Technical Service Bulletin (TSB)
Diesel Exhaust Fluid (DEF) Fluid Freezing

REFERENCE:	TSB: 14-005-24 GROUP: 18 - Vehicle Performance	Date:	June 28, 2024	REVISION:	14-003-23
VEHICLES AFFECTED:	<p>2019 - 2022 (DJ) RAM 2500 Pickup 2019 - 2022 (D2) RAM 3500 Pickup 2019 - 2022 (DD) RAM 3500 Cab Chassis 2019 - 2022 (DP) RAM 4500/5500 Cab Chassis This bulletin applies to vehicles equipped with the 6.7L I6 Cummins Turbo Diesel engine (Sales Codes ETL and ETN) or a 6.7L I6 Cummins HO Turbo Diesel engine (Sales Code ETM).</p>	MARKET APPLICABILITY:			
		<input checked="" type="checkbox"/> NA		<input type="checkbox"/> MEA	
		<input type="checkbox"/> SA		<input type="checkbox"/> IAP	
		<input type="checkbox"/> EE		<input type="checkbox"/> CH	
CUSTOMER SYMPTOM:	<p>**Customers must experience a Malfunction Indicator Lamp (MIL) illumination and the vehicle must exhibit/set the following Diagnostic Trouble Code (DTC):**</p> <ul style="list-style-type: none"> ● P203E-00 - Reductant Level Sensor 1 Circuit Intermittent-Erratic. <p>Customers may also experience one or more of the following:</p> <ul style="list-style-type: none"> ● Repeated freeze/thaw cycles of the urea tank to cause solid DEF crystal

Fig. 1
DEF Tank Assembly

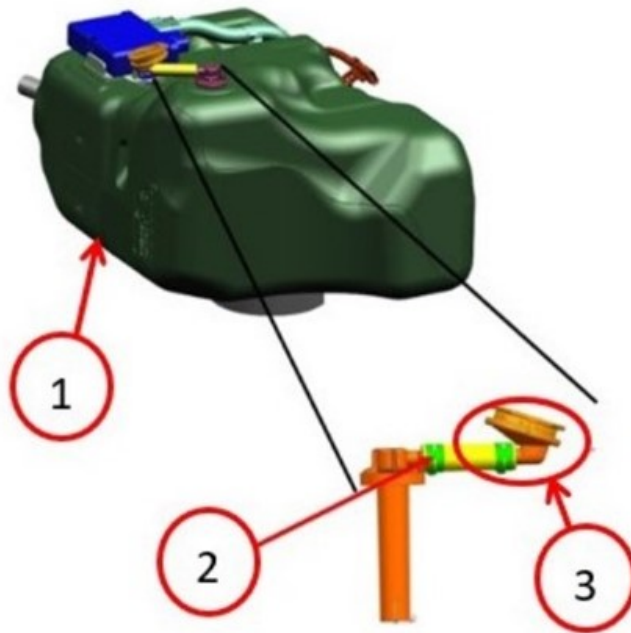
1. ****Loosen the hose clamp on the Grade Vent Valve (GVV) hose and replace the GVV from the DEF tank Fig. 1.**
